October 29, 2001
L-01-113U. S. Nuclear Regulatory Commission
Attention: Document Control Desk
Washington, DC 20555-0001**Subject: Beaver Valley Power Station, Unit No. 1 and No. 2
BV-1 Docket No. 50-334, License No. DPR-66
BV-2 Docket No. 50-412, License No. NPF-73
License Amendment Request Nos. 281 and 152**

Pursuant to 10 CFR 50.90, FirstEnergy Nuclear Operating Company (FENOC) requests an amendment to the above licenses in the form of changes to the technical specifications (TSs). The proposed amendment revises the TS 3.9.3, "Refueling Operations – Decay Time," decay time of 150 hours to 100 hours.

Beaver Valley Power Station, Unit Nos. 1 and 2
License Amendment Request Nos. 281 and 152
REVISION OF TECHNICAL SPECIFICATION 3/4.9.3 DECAY TIME

Spent Fuel Pool Performance
Decay Time versus Component Cooling Water Temperature

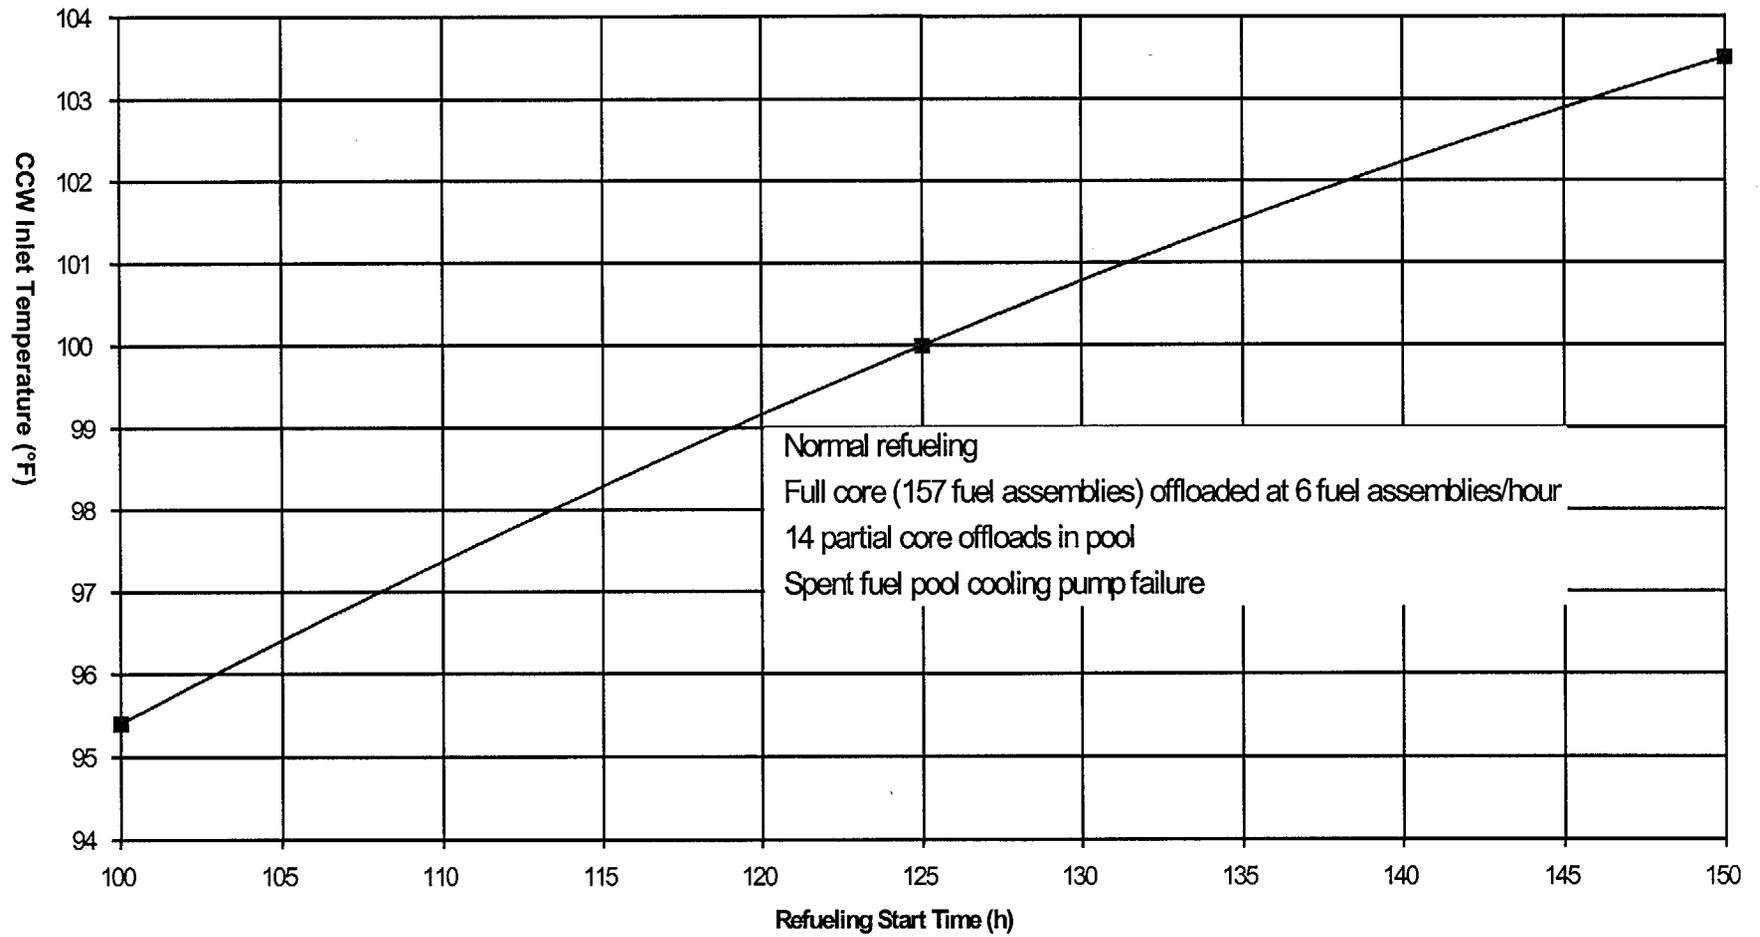
The re-analyses of SFP thermal-hydraulic performance included results for other decay times greater than 100 hours. These analytical results are combined into graphs of decay time versus component cooling water (CCW) inlet temperature representing the conditions that will limit the SFP temperature to 170 °F for Unit Nos. 1 and 2, respectively. These graphs are presented in corresponding Attachments D-1 and D-2. Administrative controls will be established in accordance with the commitment stated in Attachment E.

Administrative controls will be established to control decay times prior to the movement of irradiated fuel assemblies from the reactor core based on the "Decay Time versus Component Cooling Water" curves provided in Attachments D-1 and D-2.
